# Argay Terrace Neighborhood Association & Communication to Council Presentation on 03.29.17, 2:00 P.M.

## Response to PBOT/Treat Response to ATNA Questions. 03.16.17:

# # 1-A Overall of Castlegate Site and Surrounding Neighborhood

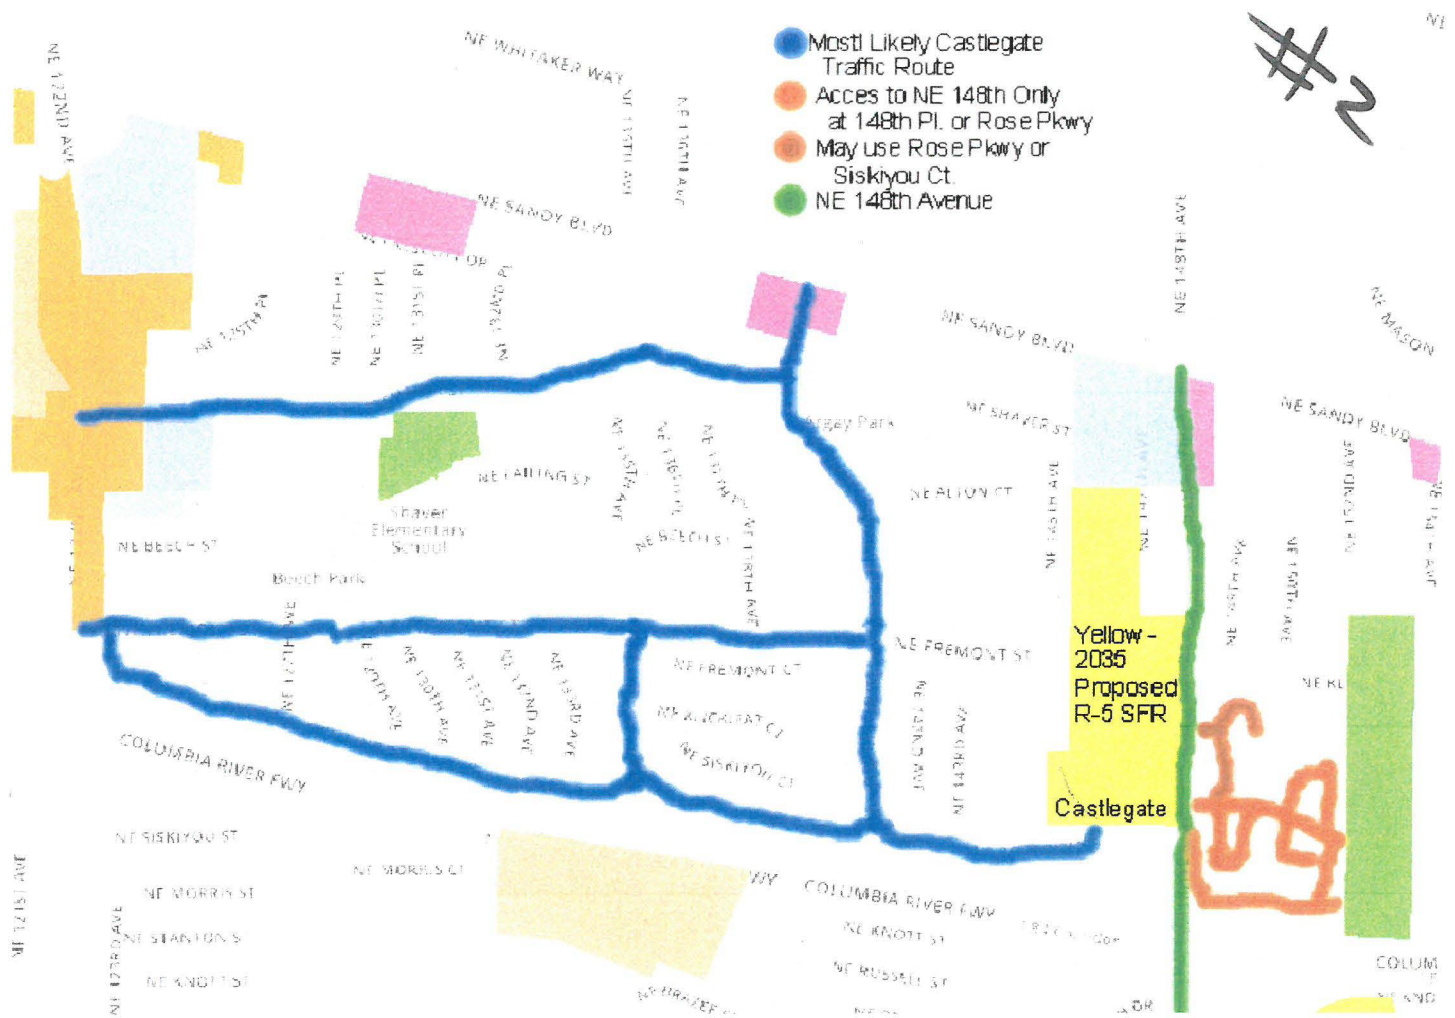
Our president, Doug Cook, will be meeting with Commissioner Saltzman and Matt Grumm to review our request for PBOT to do a simple, low-cost study to resolve our safety issues. The study will involve only a few hours of PBOT engineer time. We ask that the engineer use the same measurement PBOT used to determine the safety of the NE 148<sup>th</sup> Place intersection across from Castlegate. PBOT's engineer determined that intersection to have enough stopping sight distance to be safe. We want PBOT to use the same measurement for Castlegate's connection to NE 148<sup>th</sup>. (See attached picture #1-A)

**Traffic Patterns:** Shows pathways through Argay if Castlegate is connected to NE Rose Parkway and Comp Plan 2035
